LTANr 68/53

Additional fair lead for brake cable.

Kind of make for installation at the completed glider. Scale 1:1

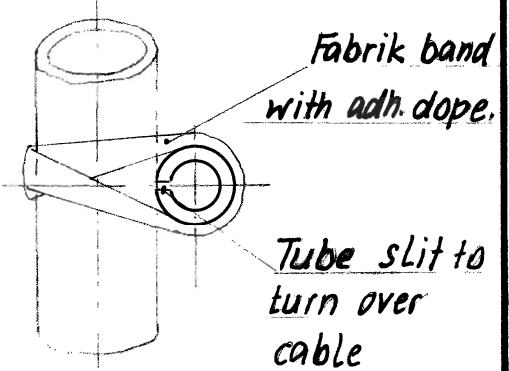
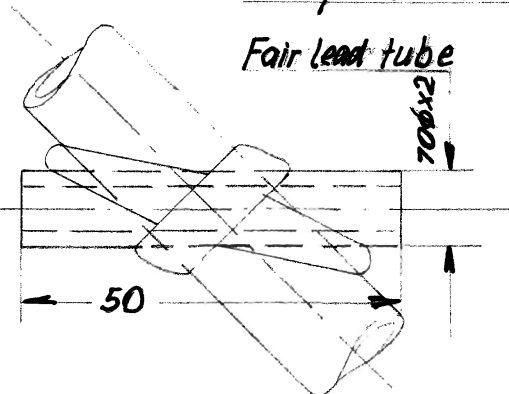
Reason: Installation of an additional fair lead in the brake cable to prevent slinging the cable around the hook lever.

Description of modification: All aircraft are to be fitted with an additional fair lead. For the new ones these are made as common. The allready delivered aircraft are to be modified after the following drawing.

Belly hook.
